GMU Reference: 15230

**Re: State Significant Development Application and Variation of the Sydney Cove  
Redevelopment Scheme for the 'Remediation, Renewal and Adaptive Re-Use of Campbell's  
Store', The Rocks (SSD 7056).**

GM Urban Design & Architecture (GMU) has been engaged by the owners of 8 Hickson Road, The Rocks to review the State Significant Development Application for Campbell's Stores, The Rocks and provide an independent urban design assessment on the appropriateness of the proposed works. No 8 Hickson Road (our clients' property) is the closest residential building to the proposed extension of Campbell's Stores, referred to as 'Bay 12'.

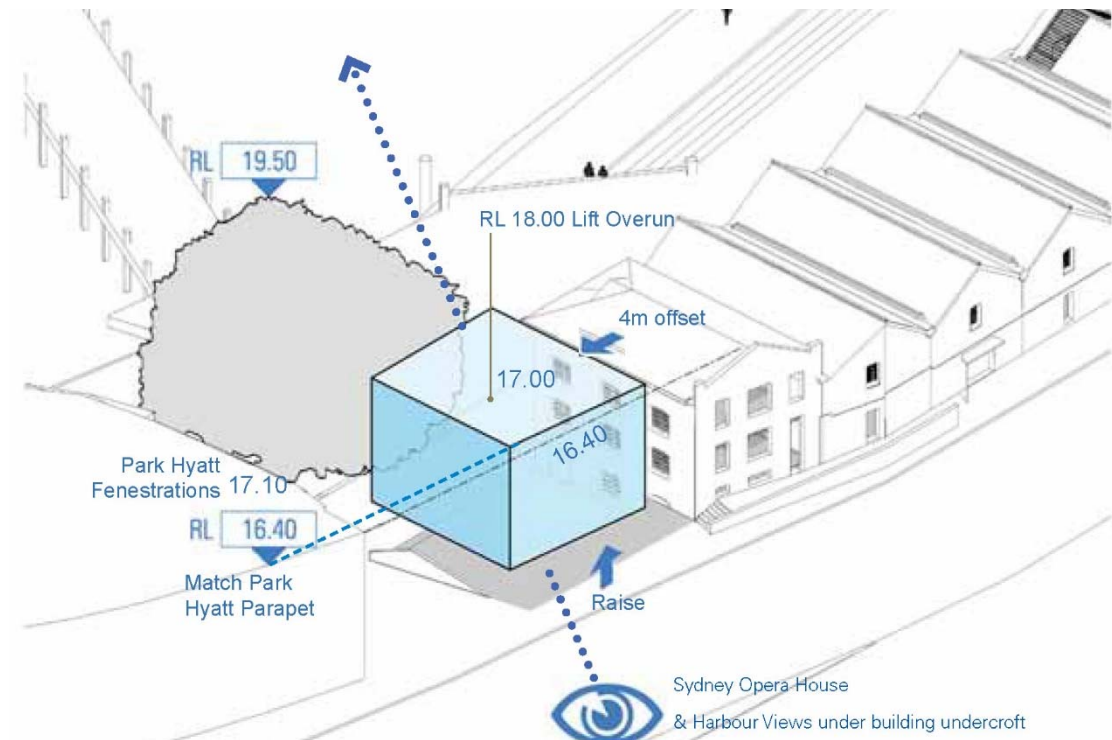
11. Construction of a 4 storey high building to the north of Bay 11 and separated from the heritage building by approximately 4m. It is referred to as Bay 12. The proposed new building has a raised ground level to match the level of the footpath along Hickson Road. The space under the raised ground level is proposed to be used mainly for toilets and storage. The raised ground level is

higher than the ground level of Bay 11 and as such it obstructs the outlook of the existing windows facing north at ground level.

The new building proposes an open undercroft that is 2.5m high above ground level. It is open except for 4 columns and the vertical circulation connecting the 3 levels above. The ground level appears to be intended to provide public access under the building from Hickson Road to the foreshore; however, the architectural drawings indicate potential for some dining within this space, but with no particular function specified for this area.

The building is 12.3m high (plus 1m for the lift overrun) when measured from the proposed new ground level of RL 4.6. This ground level is almost 2m above the existing ground level of the foreshore to the east. The proposed height of the lift overrun for Bay 12 is RL18 and the roof is at RL17. The justification of the height is based on the small decorative fenestration element of Hyatt Hotel building. We do not consider this element forms a suitable reference point. Given Bay 11 is at RL 15.4 (ridge) the roof of the new building will be significantly taller than the ridge and nearly 4m higher than the gutter line of the stores. The proposed structure will be the highest structure in this row of buildings on the eastern edge of Hickson Road.

The proposed new building is clad in glass blocks and has cubic form. Its character is that of a 'glass box' on stilts. The use of glass blocks as the only material for the building's façade is intended to increase transparency of the building. The building consists of 3 levels and will have services, ceilings as well as concrete slabs and the roof structure. These elements will not be transparent. The proposed glass blocks are also not transparent. As a result, the building will be quite solid.

*The existing height diagram from SCRAS*

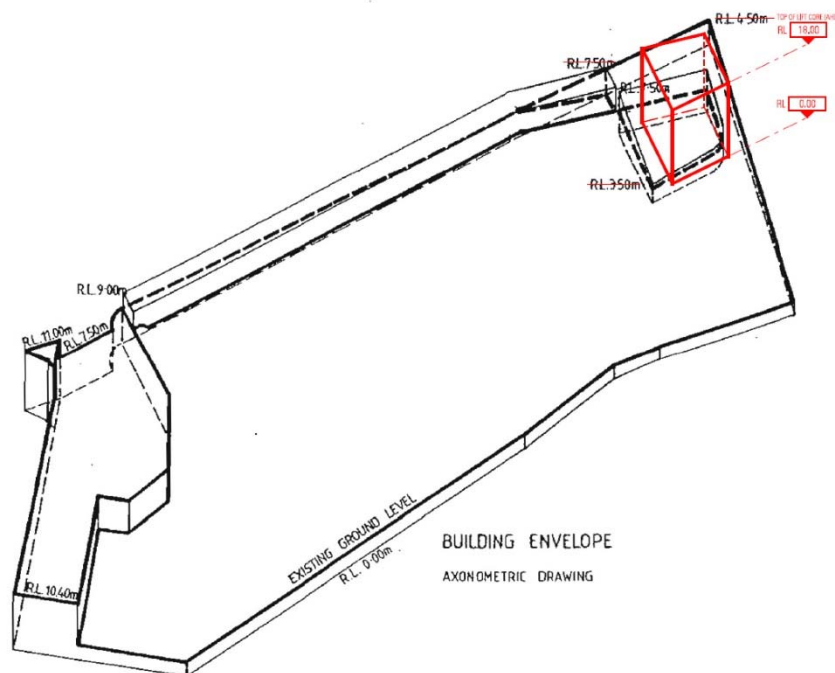
The site is affected by a height limit under the Sydney Cove Redevelopment Authority Scheme – Building Site Control drawing XVII. This indicates the maximum height of any structure beyond the heritage building. The diagram is shown below for reference. It illustrates that any structure on the northern end of the site is not to exceed an RL of 7.5m towards the west and RL 3.5 towards the east. These heights only allow for a structure of approximately 3m to the west and 0.5m on the site.

This application seeks to amend the building envelope diagram over the site to a proposed maximum height of RL 18. This is an increase in height of 10.5m to the west and 14.5m to the east.
